# **Abandoned Solvent Center Inactive Hazardous Waste Site**

**Pompey, Onondaga County, New York  
Site No. 7-34-035**

## **RECORD OF DECISION**

**RESPONSIVENESS SUMMARY  
for the  
Proposed Remedial Action Plan**

Figure 2-4 ABANDONED SOLVENT CENTER LOCATION OF SLURRY WALL AND COLLECTION TRENCH FOR GROUNDWATER ALTERNATIVE 3

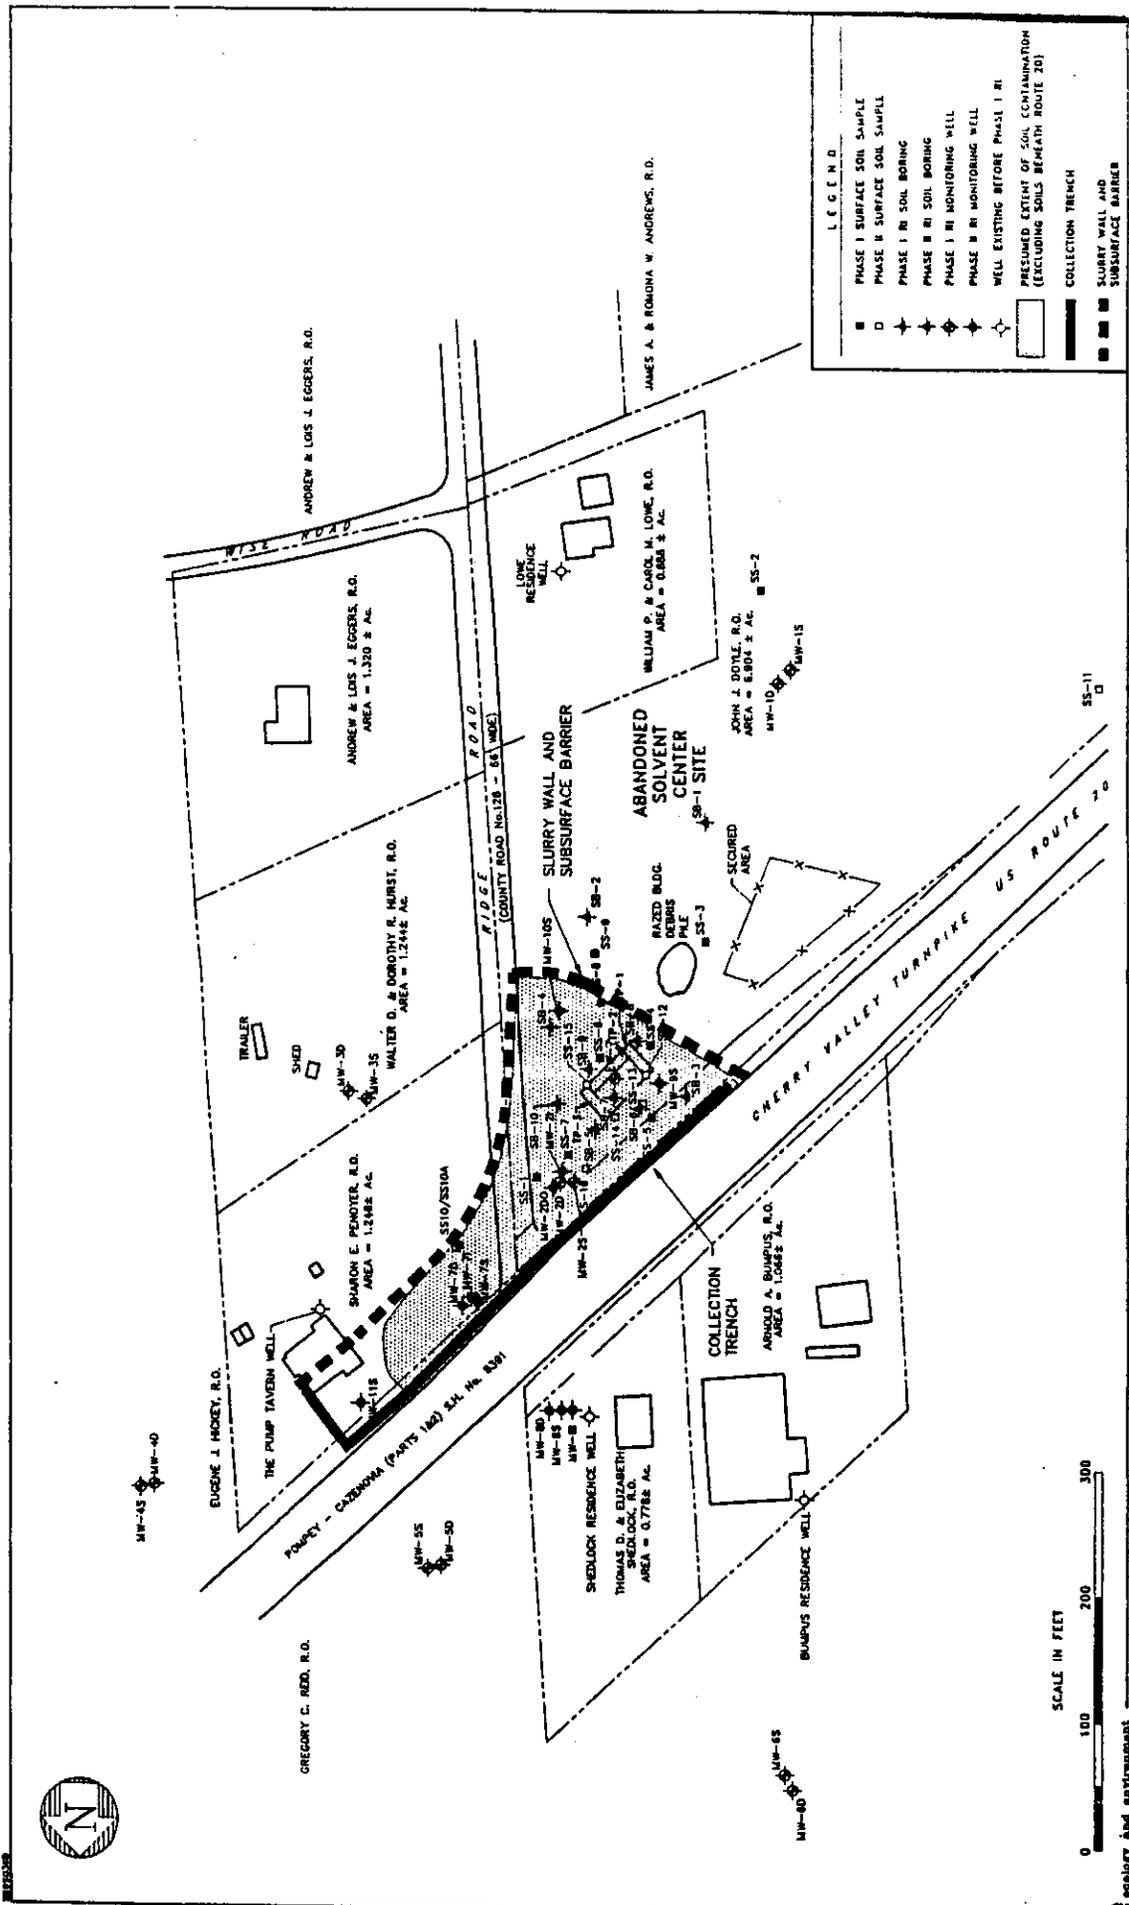
17. **COMMENT:** The design objective for the installation of an upgradient bentonite deflector wall should be clarified.

On a related matter, the Commenters feel that the design objective for the installation of the upgradient bentonite wall deflector should be clarified. The schematic alignment of the deflector wall, shown in Figure 2-4 of the PRAP, suggests that this measure is being proposed to substantially reduce the horizontal flux of water through the overburden aquifer into the Site area. For clarity, the

**RESPONSE:** The location of the bentonite slurry barrier wall has been redefined. The objective is to eliminate, to the extent possible, any horizontal flow of groundwater within the overburden into the contaminated area. It will, therefore, connect to each end of the collection drain to form a closed system as shown in the revised Figure 2-4 in the ROD.
